FIRE SAFETY INSPECTION REPORT

**TEXEUROP (BD) LTD.
VOGRA, JOYDEVPUR**

ACCORD
on Fire and Building Safety in Bangladesh

July 13, 2014

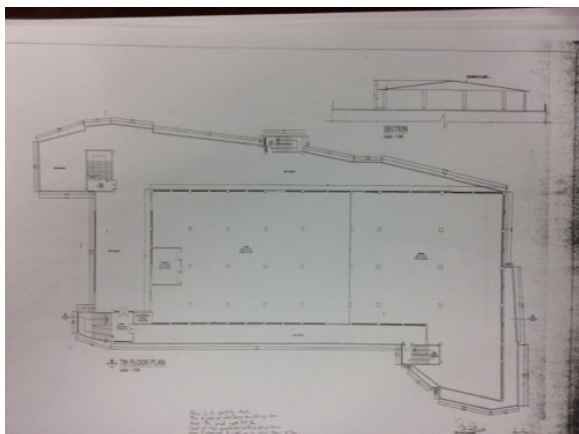
Sliding doors are provided at building exits, exit stairs, and exit discharges.

Replace all sliding doors along the means of egress with side-hinged, swinging egress doors.

If locks are required for security reasons, utilize special door locking features complying with NFPA 101.

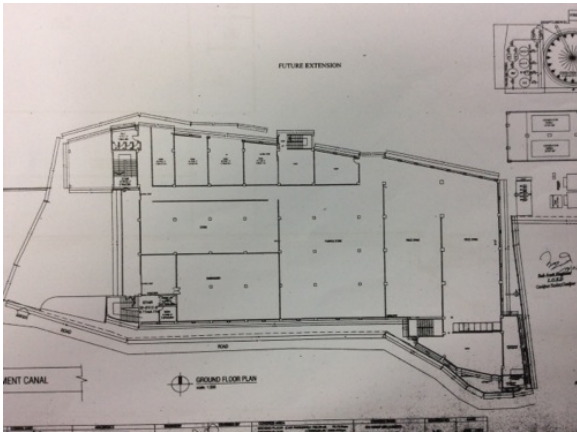
F-10	Egress	The exits are not remotely located from each other in the embroidery room such that a single fire event could compromise both exits.	Modify exit arrangement. OR Provide an additional exit. OR Provide sprinkler protection in accordance with NFPA 13.	Within 6 months
------	--------	--	---	-----------------

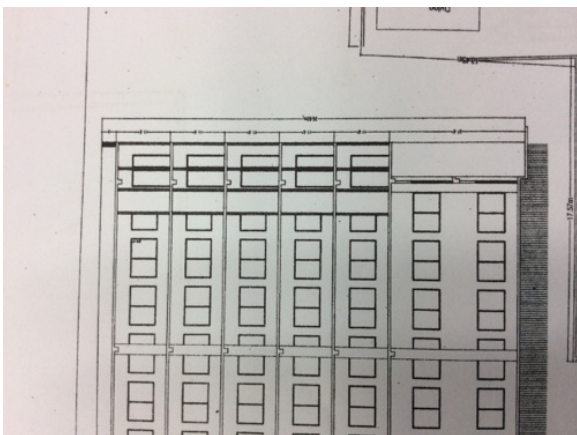
F-11	Fire Protection	The high-rise building has an occupied floor greater than 23m (75 ft) and is not provided with automatic sprinkler protection. The large occupant loads, heavy fuel loading, and anticipated extended egress times warrant sprinkler protection.	Provide automatic sprinkler protection throughout the building in accordance with NFPA 13.	Design within 6 months, install within 12 months
------	-----------------	--	--	--
